RESPONSE TO BRISBANE CITY COUNCIL INFORMATION REQUEST: S.13 OF THE DEVELOPMENT ASSESSMENT RULES

CHANGE APPLICATION (OTHER CHANGE) PURSUANT TO SECTION 82 OF THE PLANNING ACT 2016 OVER LAND AT 37 BROWNING STREET, SOUTH BRISBANE

COUNCIL REFERENCE: A006971478

37 Browning Street, South Brisbane

Figure 1: Proposed Building Height Transition Outcome

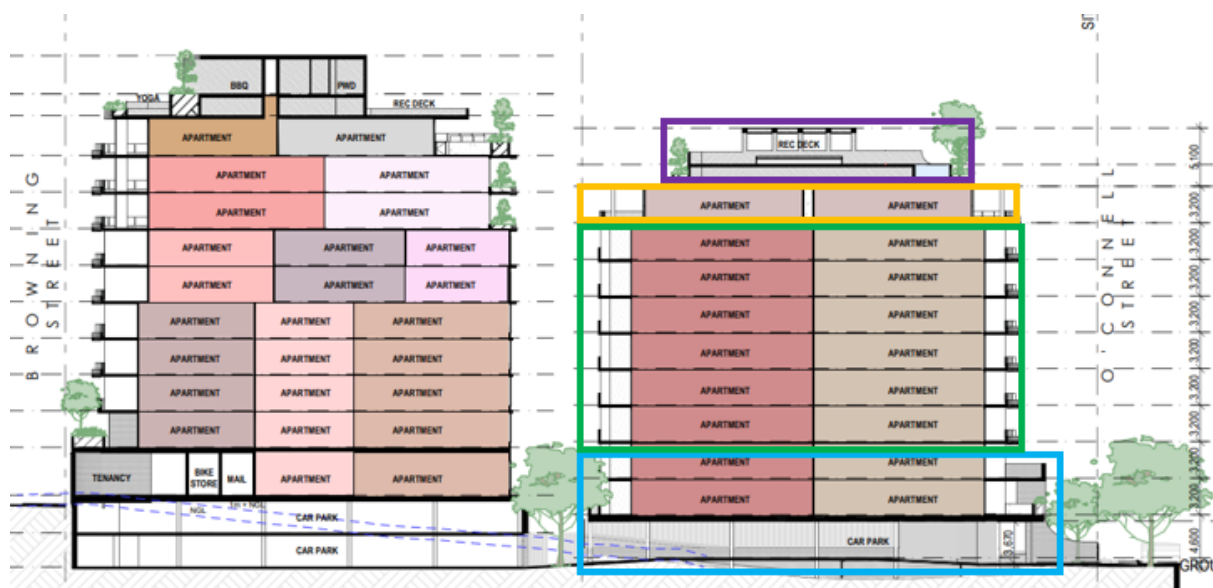
As per the requirements of the South Brisbane riverside neighbourhood plan code and the Multiple dwelling code, development along O'Connell Street is to provide a transitional built form to the lower scaled residential zoned (LMR 2-3) dwellings, located opposite to the site. While it is acknowledged that the development provides a two-storey form to the street, the proposed 10 storey tower components are not sufficiently setback from the frontage to enable a sensitive built form interface to the adjacent predominantly 2 storey scaled character. To address and AO3/PO3/AO4.2/PO4 PO3/AO13.2/PO13 of the Multiple dwelling code and AO4.8/PO4 of the South Brisbane riverside neighbourhood plan code provide:

- (a) An amended design that provides a greater transition of no more than 2 storeys higher than the lower scaled LMR zoned dwellings opposite in O'Connell Street within 10m of the front boundary or;*
- (b) Provide an amended design that includes a greater setback of 10m to the tower elements.*

In response to Item 1, the Applicant has made changes to the front setback to O'Connell Street and provided additional contextual material to assist with Council's assessment.

- The **ground level and first two floors of the building** (Basement – 2, Basement -1 and Ground Floor – plan references) of the building represents a three (3) storey podium form (in keeping with the 2 - 4 storey podium outcome under the Neighbourhood Plan). These levels are setback 4.5m from the front boundary (exceeding the 4m setback under Table 9.3.14.3.1 of the Multiple Dwelling Code).

- **Levels 3 - 8** (Levels 1 – 6 – plan references) of the tower form are further recessed and stepped in, creating transitional form distinct from the podium at the lower levels. Levels 3 – 8 comprise curved balconies that are setback between 6.63 metres to 8.1 metres and represents an increased front setback outcome from that originally proposed (5.63m to 7.1m).

- At **Level 9** (Level 7 – plan reference) the building line is further recessed to 10m (consistent with the originally proposed outcome).
- The **communal roof terrace** remains positioned centrally within the tower form, setback 12.8 metres behind a landscape planter and is not perceivable from the streetscape (from 11.8m originally proposed). Furthermore, it is noted that there have been changes made to the rooftop recreation deck and as a consequence, no longer constitutes a technical storey pursuant to the City Plan 2014 definition.

Figure 4: Proposed outcome and future transition outcome - Shadow Diagrams (Source: DAH Architecture, 2026)

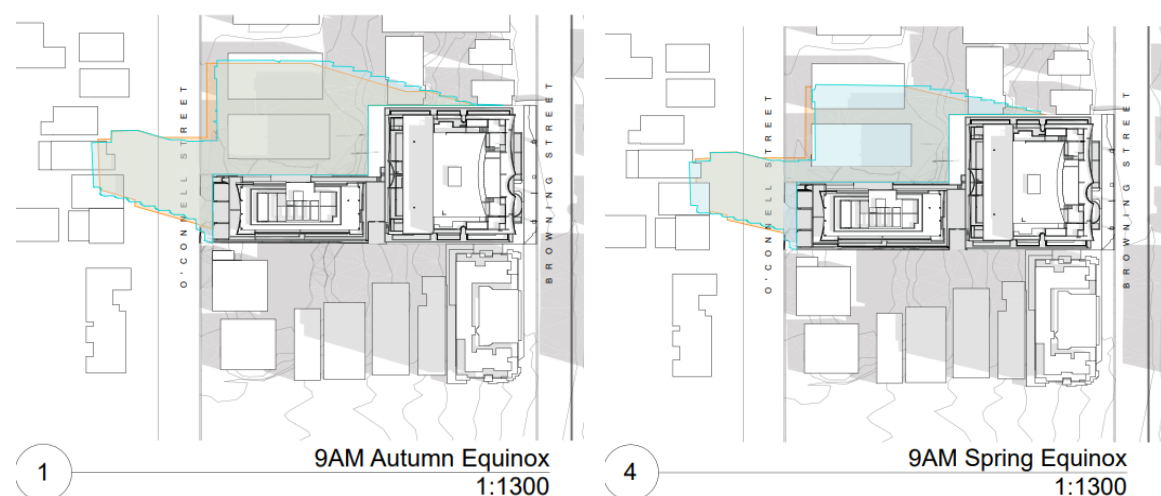
- i. an outcome in accordance with the acceptable outcome height*
 - ii. the proposed development outcome*
 - iii. A design outcome for a different height outcome including a compliant rooftop garden*
 - iv. Shadow diagrams that incorporate the existing overshadowing impacts of existing and approved adjoining properties.*
- (c) Include a view analysis to ensure significant views and vistas to the ridgeline of the Taylor Ranges are maintained in response to PO2; and*
 - (d) Includes a 3D model of the amended proposal suitable for use with Virtual Brisbane and submitted via the following link: virtualbrisbane@brisbane.qld.gov.au.*

- As set out in response to **Item 2** of Council's Information Request, the shadow diagrams demonstrated that the proposed building height will not impact upon the adjoining Low Medium Density Residential land to the south of O'Connell Street, albeit minor incursions at 12pm during the winter solstice, 9am during the autumn equinox, and 9am during the spring equinox.

In the context of both shadow impacts associated with the proposed outcome and future transition outcome, it is clearly demonstrated that the proposed transition outcome does not further exacerbate, nor significantly increase shadow impacts that would otherwise be generated by the future building height transition outcome to this residential interface. Refer to the Shadow Diagrams included in **Attachment B**, for further detail.

Figure 6: Original Level 01 configuration (Source: DAH Architecture, 2026)

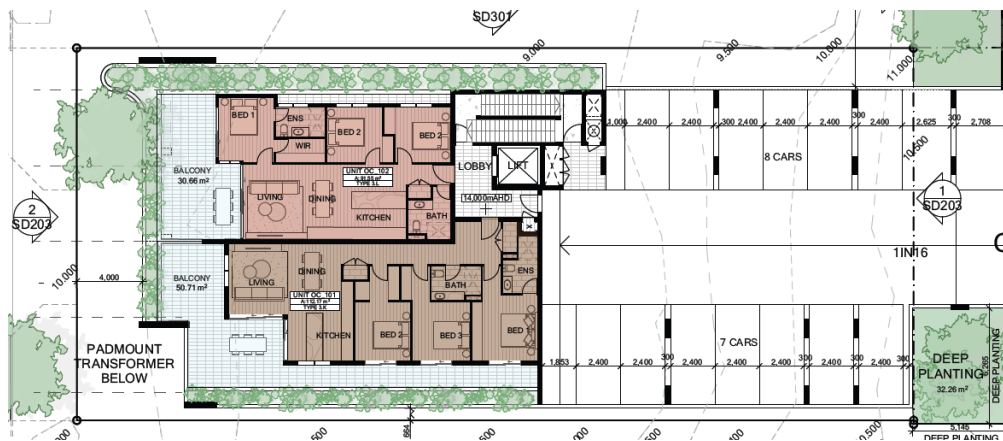
The South Brisbane riverside neighbourhood plan code anticipates acceptable side boundary setbacks of 3m or 5m where windows of habitable rooms face side boundaries (AO4.2). The proposed 660mm setback to the south-eastern boundary represents a substantial non-compliance and is considered to unreasonably constrain the future development potential of the adjoining site, including opportunities for appropriate landscape buffering. The inclusion of open carpark areas and side-facing terraces within 1.8m of the boundary further exacerbates issues of building bulk, visual dominance, and potential overlooking.

(a) Provide amended plans that increase the side boundary setbacks to greater align with AO4 of the South Brisbane riverside neighbourhood plan code.

- In response to Item 5 of Council's Information Request, the Applicant proposes to remove the above ground car parking area within the O'Connell Street Tower (Level 01) to provide two (2) additional residential units. The change has provided a 3 metre setback to the building line and whilst the terrace over the roof to the car park below, largely comprises landscaping and does not provide for recreation activities (it is for maintenance purposes). The landscape planter provides screening to mitigate privacy and overlooking concerns on the adjoining land. Refer to **Figure 6** and **7** below.

- As presented in **Figure 7** above, the centralised bridge component that previously provided vehicle connection between respective car parking levels has been removed, resulting in the separation of the towers which provides a positive outcome from an interface perspective. The proposed

Figure 12: Proposed screening elements to ground level car parking - O'Connell Street Tower
(Source: DAH Architecture, 2026)

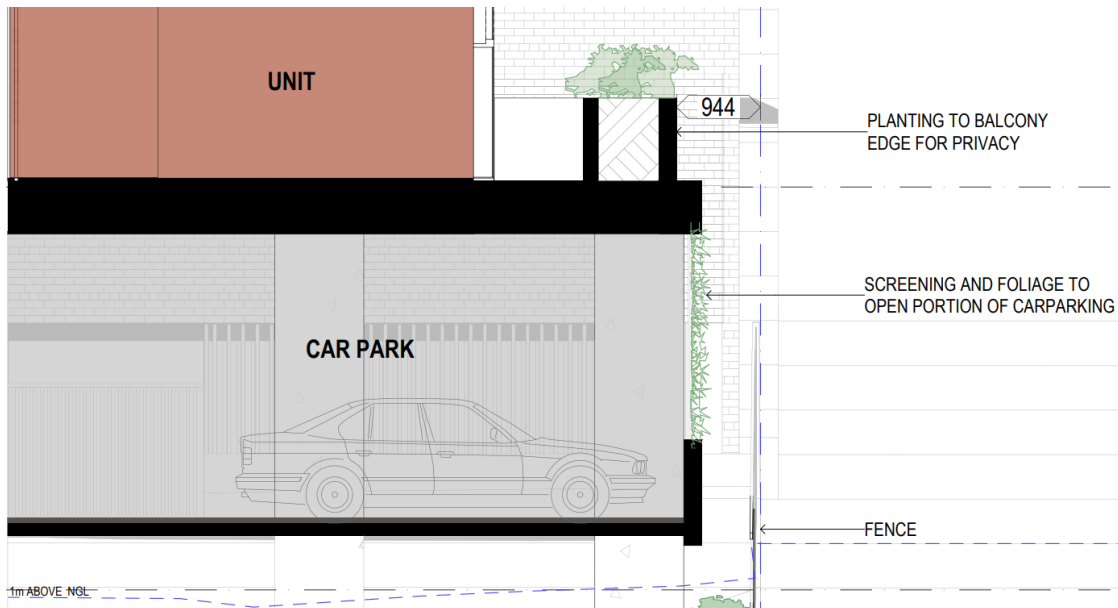
- (a) *Provide amended plans that incorporate screening / full perimeter articulated walls to the carpark area. Included sectional details of screening and light mitigation treatments.*

In response to **Item 5** of Council's Information Request, the proposed ground level car parking area has been appropriately screened to minimise adverse impacts on the streetscape character and amenity of adjoining residents, as detailed herein.

- As detailed within the Architectural Plans (**Attachment B**) and the Landscape Concept Plan (**Attachment D**), the proposed car parking area is setback behind a 0.6 – 1 metre wide landscape buffer along the south-eastern and north-western elevations, which will contain a combination of layered subtropical plantings including small shrubs, canopy trees and climbing plants that will be planted at an established size. Refer to **Figure 12** below.

- Metal screening will be integrated throughout the façade of the car parking area to offer an additional element of screening, whilst still allowing for air circulation and ventilation within the car parking area. Furthermore, the metal screening proposed will support climbing plants (affording additional screening). The proposed screening elements are illustrated in **Figure 12** below and within the Architectural Plans included in **Attachment B**.

Figure 16: Bin store - O'Connell Street Tower (Left) and Browning Street Tower (Right)

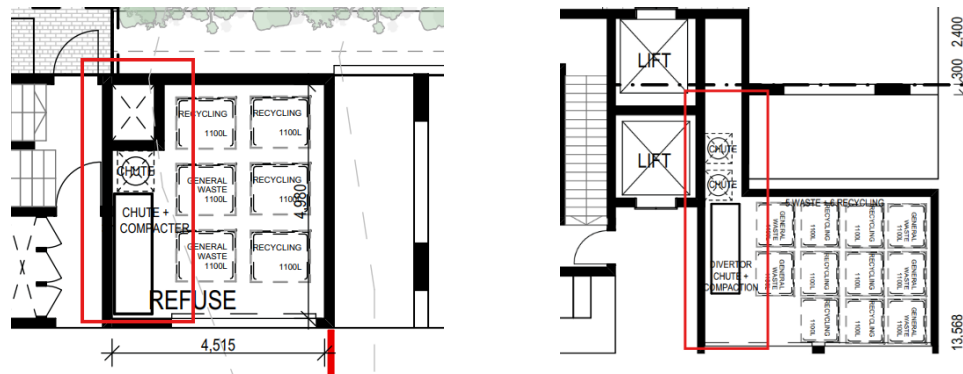
In accordance with PO32/AO32 of the Multiple dwelling code, PO8/AO8.1 & AO8.2 of the Infrastructure design code and PO18/AO18, PO19/AO19.2 & AO19.3 of the Transport, access, parking and servicing code provide the following:

- Internal heights and clearances remain consistent at a minimum height of 3.6m to accommodate the RCV envelope along the full extent of the driveway / loading bay.
- In response to **Item 8(c)**, the revised Architectural Plans demonstrate a minimum vertical clearance of 3.6m to the lowest projection is achieved over the aisle that is to be trafficked by an RCV. Refer to the Architectural Plans prepared by DAH Architecture included in **Attachment B**.
- In response to **Item 8(d)**, the Architectural Plans have been updated to clearly identify the chute diverters and 3:1 refuse compactors within both refuse rooms. Refer to Drawing No. SD105 of the revised Architectural Plans (**Attachment B**) and **Figure 16** below.

- The size of the retail bin store (including length and width) has been clearly annotated on the revised Architectural Plans (**Attachment B**), in response to **Item 8(e)** of Council's Information Request.
- Having regard to **Item 8(f)** of Council's Information Request, the retail bins will be permanently stored in the collection point given the small number of bins required to service the retail use(s) (i.e., 2 x 240L bins). Staff will be responsible to take all waste and recycling material from the retail tenancy to the bins located at the collection point at the end of each working day.

Figure 17: Revised PMT Location - O'Connell Street (Source: DAH Architecture, 2026)

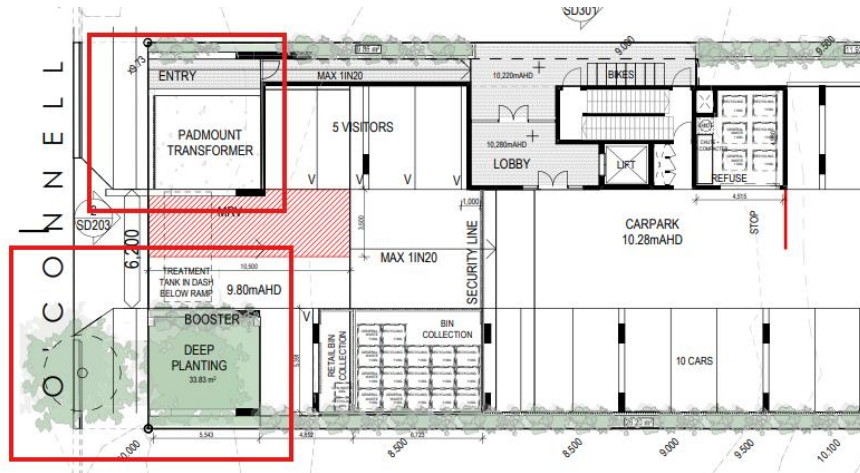
The O'Connell Street frontage contains one existing street tree that contributes to streetscape character and amenity and is protected under the Natural Assets Local Law (NALL). The tree is proposed to be retained in accordance with PO2/AO2.1 of the Streetscape hierarchy overlay code. The submitted plans indicate a separation distance of less than 2m between the tree and the driveway flare and depict a Pad Mount Transformer (PMT) directly adjacent to the tree. The PMT location is likely to adversely impact the tree and its long-term retention. Relocation of the PMT to the opposite side of the frontage is recommended.

Submit revised drawings in accordance with PO2/AO2.1 of the Streetscape hierarchy overlay code that demonstrate:

- (a) Relocation of the PMT to the opposite side of the O'Connell Street frontage;*
- (b) Provide details of how the PMT will be accessed (current location appears constrained by landscaping);*
- (c) Retention of the existing street tree; and*
- (d) A minimum 2m clearance between the street tree and the driveway crossover flare.*

- As presented in the revised Architectural Plans (**Attachment B**) and in **Figure 17** below, the pad mount transformer (PMT) has been relocated to the opposite side of the O'Connell Street frontage, adjacent to the pedestrian entrance point in response to **Item 11(a)** of Council's Information Request. The proposed deep planting area has been relocated to the southern side of the vehicular crossover and has been increased from 17.17m² to 33.8m². The proposed outcome continues to provide a generous deep planting and landscaped outcome to the O'Connell Street frontage, comprising a large feature tree, shrubs and low level plantings and ground covers.

- The revised arrangement will improve accessibility to the pad mount transformer, which is now directly accessible via the footpath along the O'Connell Street frontage and no longer constrained by landscaped elements (in response to **Item 11(b)** of Council's IR).
- As detailed on the Architectural Plans (**Attachment B**) and the Landscape Concept Plan (**Attachment D**), the existing street tree located along the O'Connell Street frontage will be retained and protected, in response to **Item 11(c)**.
- A minimum two (2) metre clearance between the street tree and the driveway flare is achieved and clearly annotated on the revised Architectural Plans included in Attachment B, in response to **Item 11(d)**.
